From:
To:
Cc: [Planning \(SMDC\)](#)
Subject: RE: SMD/2022/0267 - Blythe Park (Phases 4 and 5) - LLFA Response
Date: 03 September 2025 10:01:20
Attachments: [image001.png](#)
[image003.png](#)
[image004.png](#)
[Drainage - Development Enquiry ref 1137396 Valley Northern Limited, Carver Road, Stafford, NPD.pdf](#)

Staffordshire County Council Flood Risk Management Position

Impermeable Areas

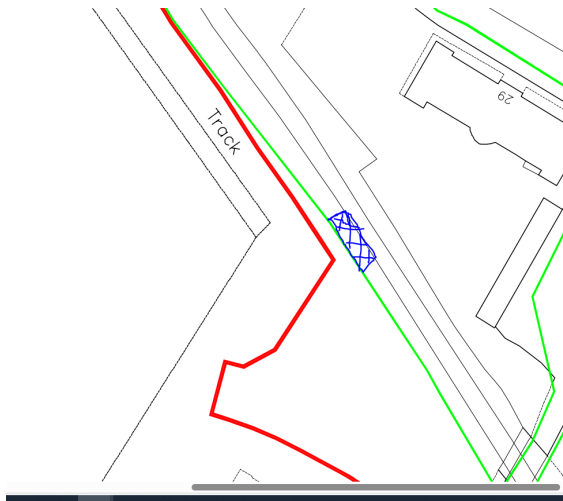
At Rev 10/11: Impermeable area for Phase 4 was confirmed by RPS *'The impermeable area is now 2.895ha and I can confirm that this includes a 10% uplift for urban creep'*. In the latest calculations provided, the model impermeable area is 2.769ha but this now includes (as requested the impermeable areas for Phases 2 and 5). Phase 2 (stated as 0.013ha) and 5 (stated as 0.193ha) impermeable area but the modelled figure has decreased. We would be expecting $2.895 + 0.013 + 0.193 = 3.101\text{ha}$ based on what you've said. Please confirm and can you also outline this on an impermeable area plan so we've got a record of these areas going forward and to demonstrate where the Phase 2 and 5 areas are added onto your modelling.
